November 1, 2019

RE: KMART REDEVELOPMENT – DRB SUBMITTAL FOR SITE PLAN

DRB PROJECT NUMBER: PR –2019–002677
APPLICATION NUMBER: SI-2019-00252

PROJECT NUMBER: STEPHEN DUNBAR, AIA
JOB NO. 5
SHEET TITLE: SITE PLAN FOR BUILDING PERMIT

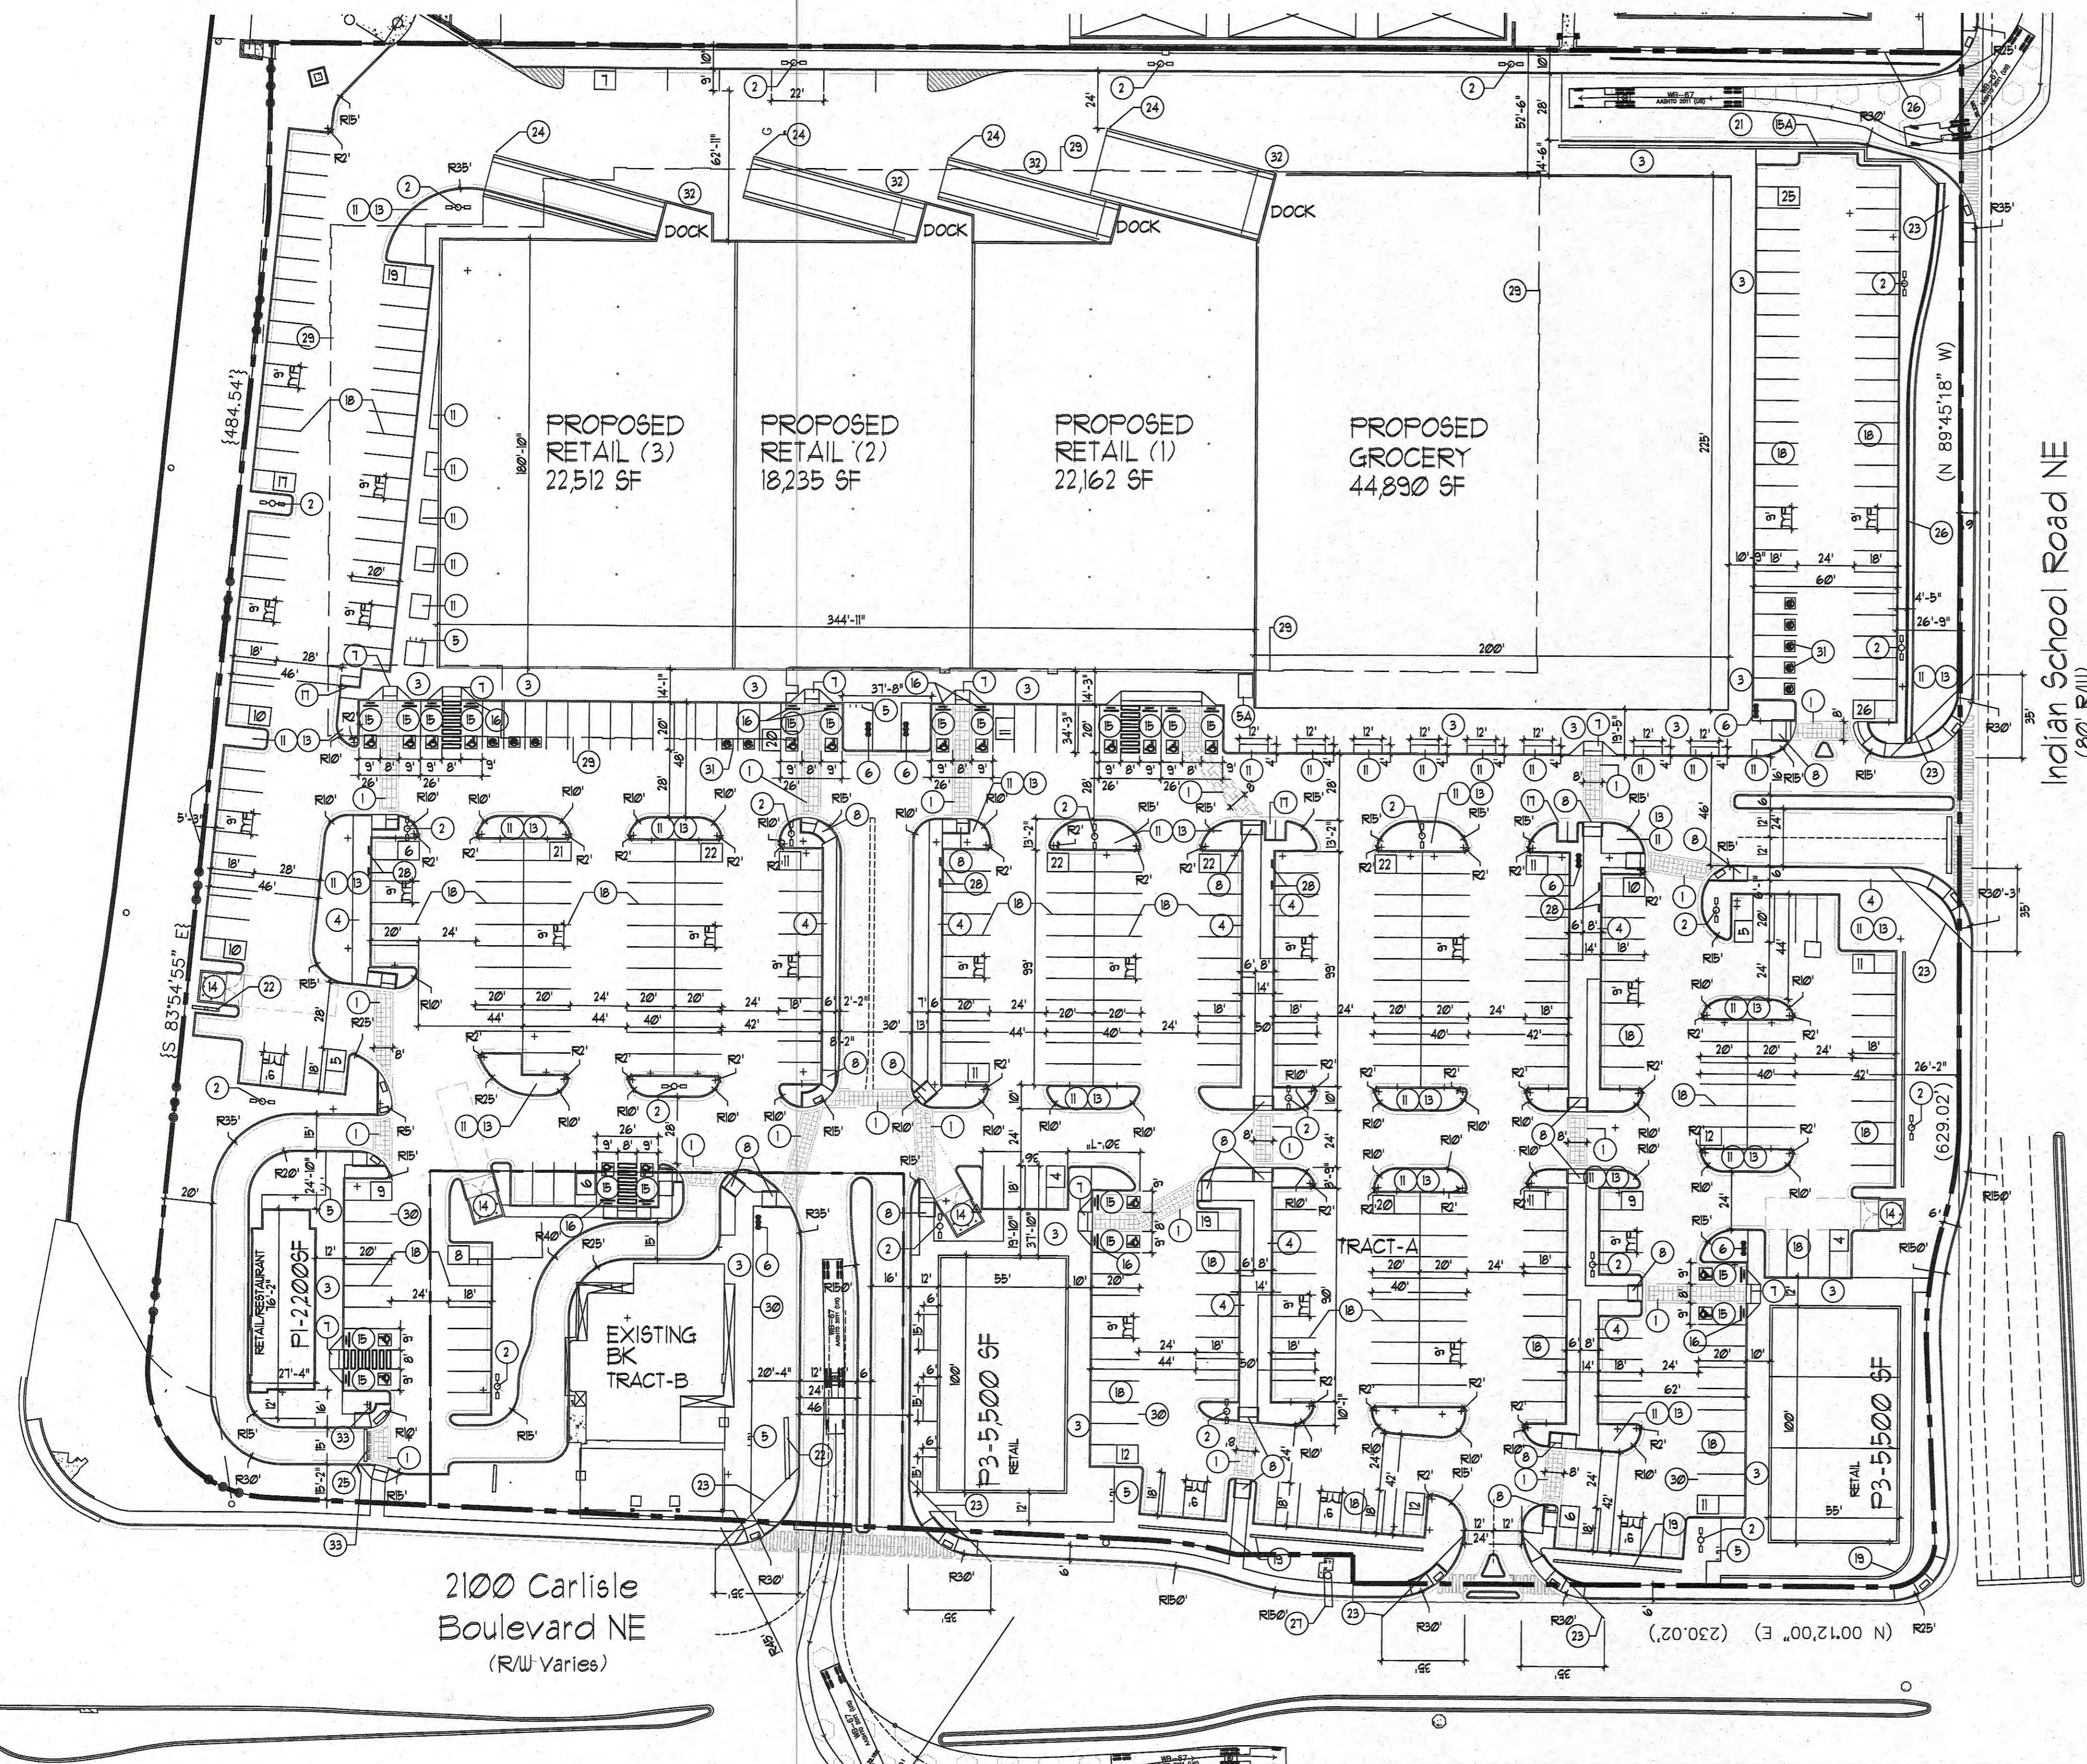
4. Dimension sidewalk on Carlisle Blvd., and show sidewalk for entire frontage. Show dimensioning (existing and new) for all lanes on Carlisle Boulevard and Indian School Road.

- a. Addressed:
 - i. See revised Site Plan sheet BP-1.
 - ii. Ramps see revised Site Plan sheet BP-1, note 7-10, and 21.
6. Call out signage on plans where needed.

- a. Addressed:
 - i. See revised Site Plan sheet BP-1.
 - ii. 6” high curbs – See revised Site Plan sheet BP-1 note 13.
8. On the northwest corner of the site, there are 15-foot wide access ways. If these access ways are meant to be one-way, provide necessary pavement striping and signage.

10. Provide turning template design for left-turning movements at the north access off of Carlisle Boulevard.
 - a. Addressed:
 - i. See revised Site Plan sheet BP-1.

- a. Addressed:
 - i. See revised Site Plan sheet BP-1.
5. Dimension the on-site walkways from the existing building and parking lot to the sidewalk along Carlisle Boulevard. Label all on-site ramps.

- a. Addressed:
 - i. See revised Site Plan sheet BP-1 note 25 and 33.

- a. Addressed:
 - i. Comment removed by City.
12. Show truck delivery route.
 - a. Addressed:
 - i. See revised Site Plan sheet BP-1.
13. Improvements look as though they encroach into the neighboring property to the east on each corner. Far north entrance appears to need to be shifted to the west.

- a. Addressed:
 - i. Lines have been adjusted to not encroach neighborhood property. See revised Site Plan sheet BP-1
 - ii. Existing trash enclosure for apartments to remain on North East corner.

DATE: **06.28.2019** sheet:
 SCALE: **AS NOTED** **A201**
 et.

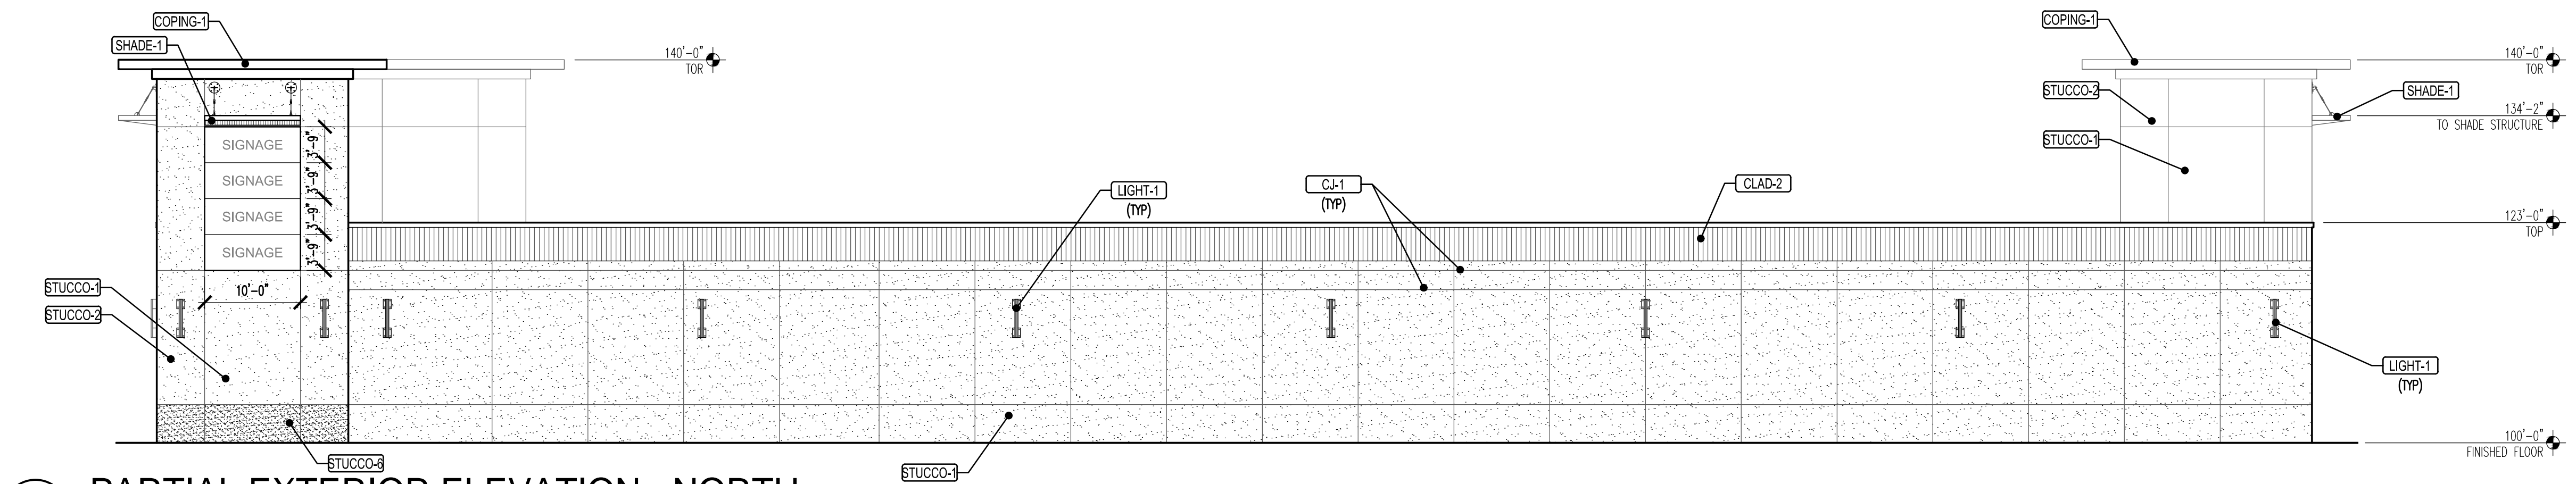
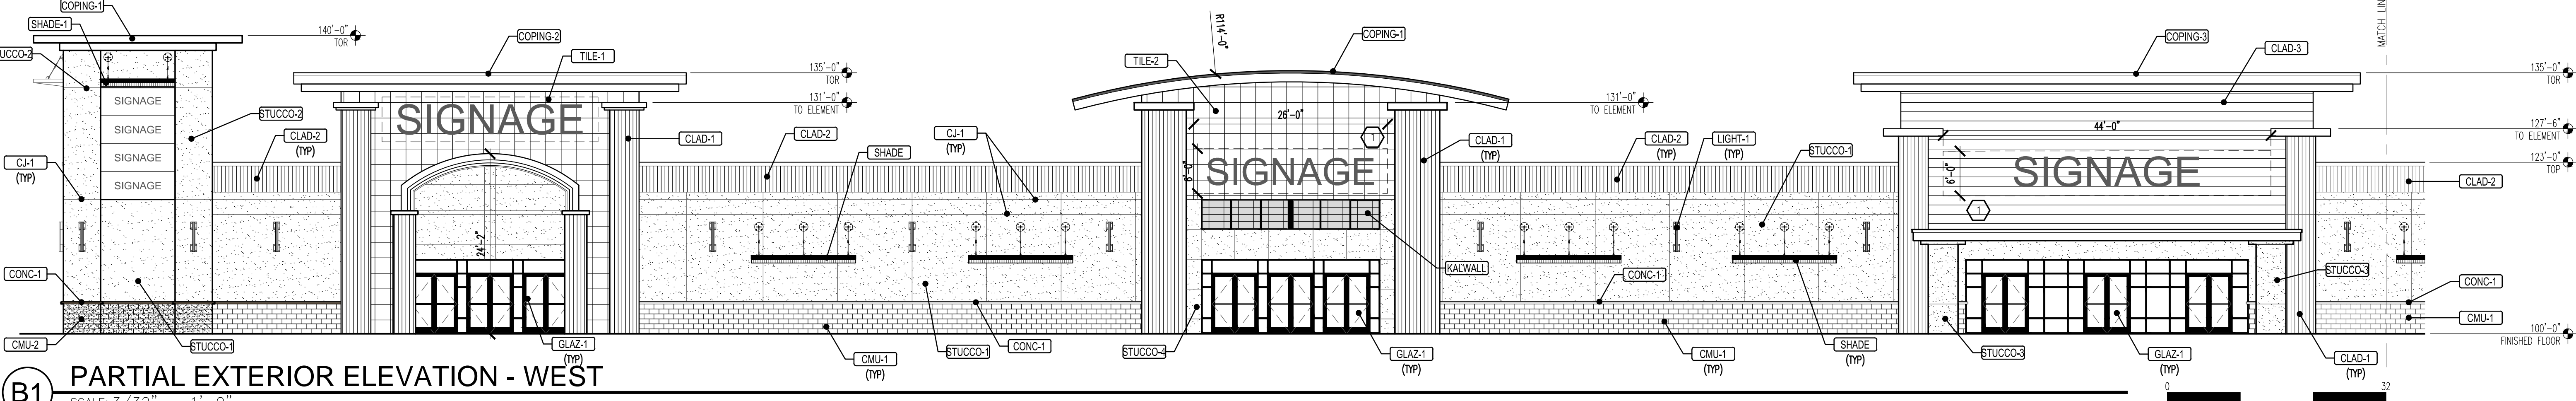
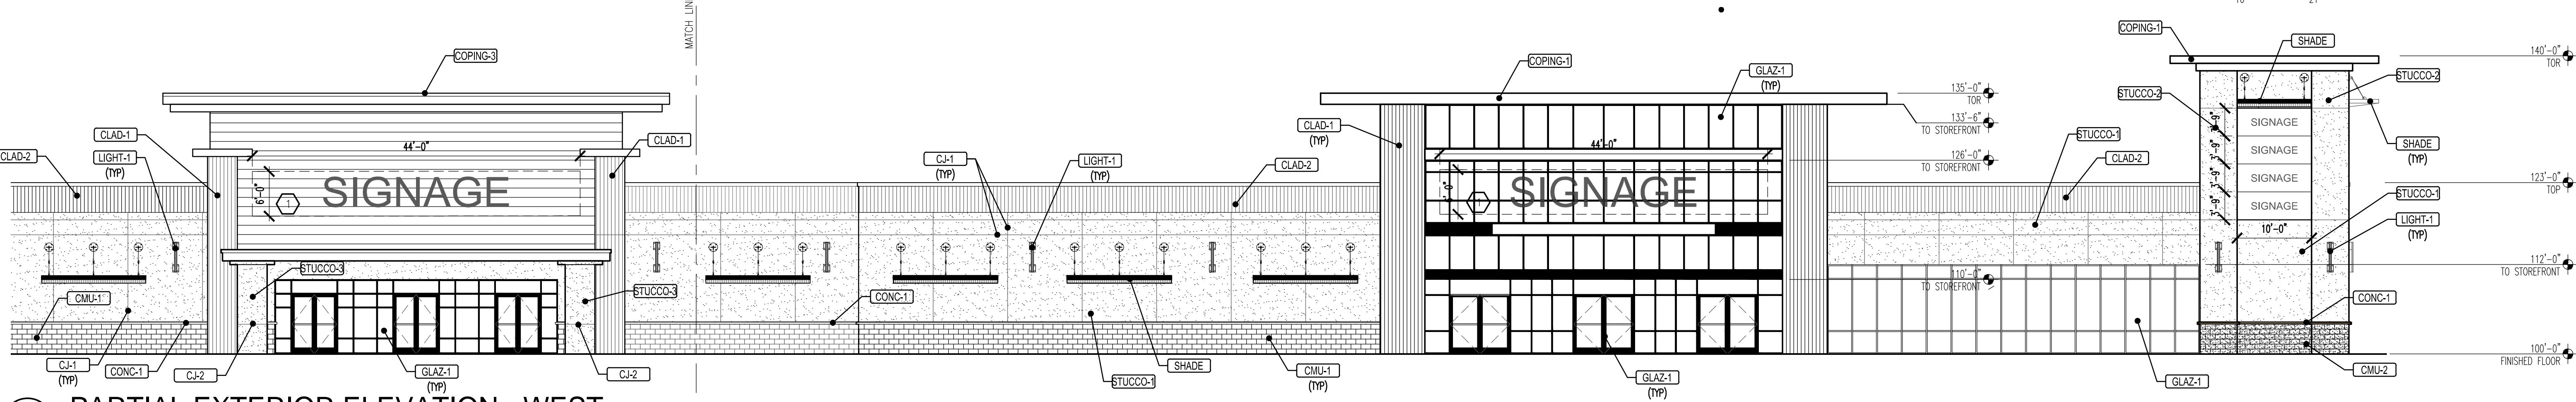
- a. Addressed:
 - i. See revised Exterior Elevation Plans – A201, A202, and A203.
7. A minimum 4-foot wide pedestrian path is needed behind the on-site perpendicular curb ramps for maneuverability. Call out these dimensions. Also call out the 6” high curb on the plan to separate parking areas from on-site pedestrian walkways.

C1 PARTIAL EXTERIOR ELEVATION - NORTH

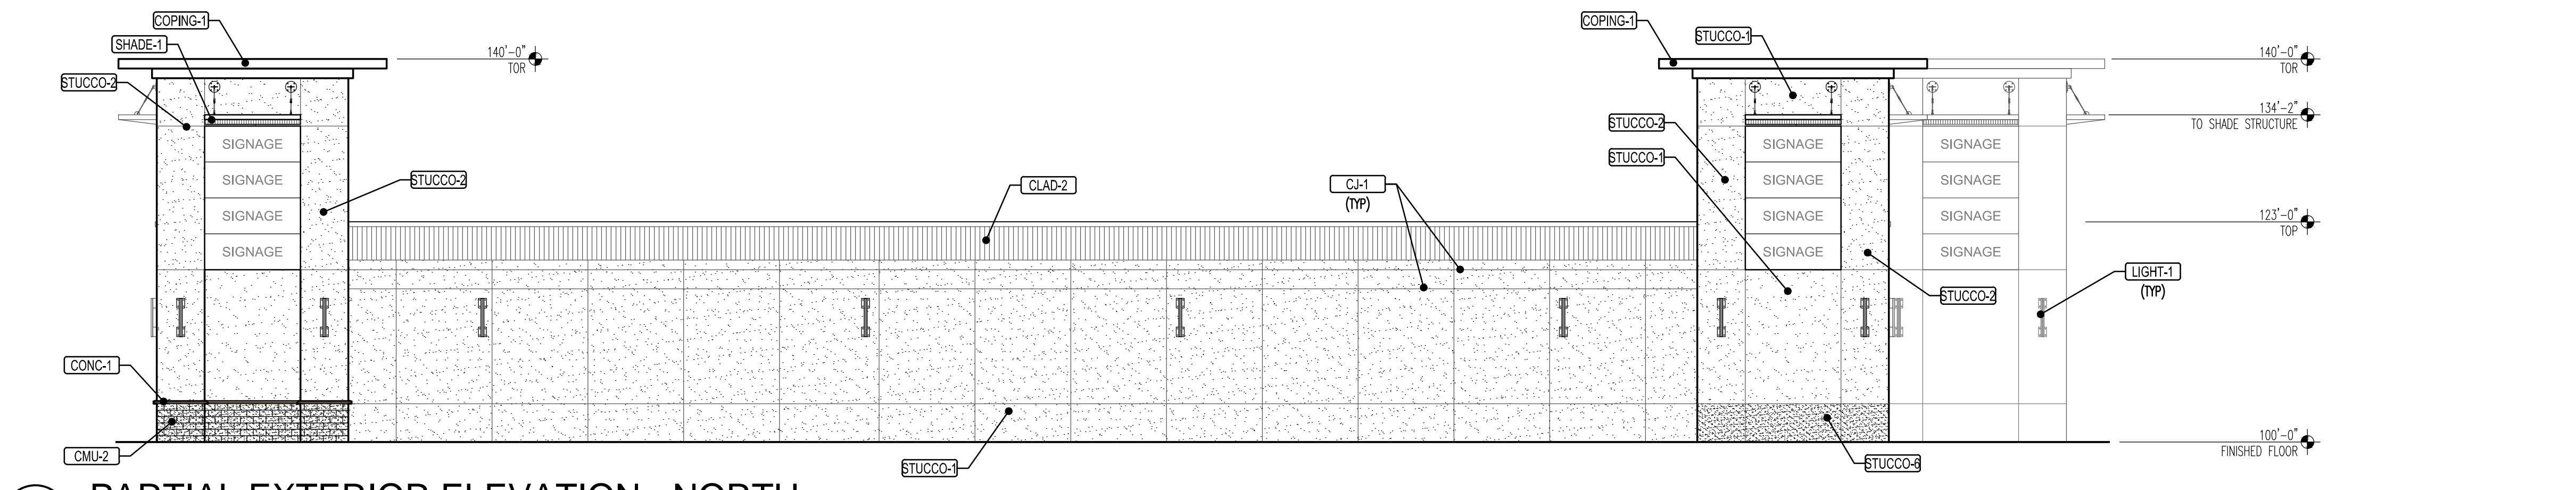
2. 10 electric vehicle spaces are required.
 - a. Addressed
 - i. See new parking calculations in the Site Data Table on BP-1 also see note 31 (10 spaces added).
3. A 15 foot sidewalk is required along the main building, please provide or request a deviation.
 - a. Addressed:
 - i. We maintain the overall 15' sidewalk along the main building but there are certain pinch points that don't meet the standard. A deviation will be requested.
4. See section 5-11-(E)(2)(a) for façade requirements- north elevation does not look like it meets these.
 - a. Addressed:
 - i. Planters where added on the North side see BP-1 – Note 11.
 - ii. Façade elevations where adjust to meet code – See A201 - C1 North Elevation.
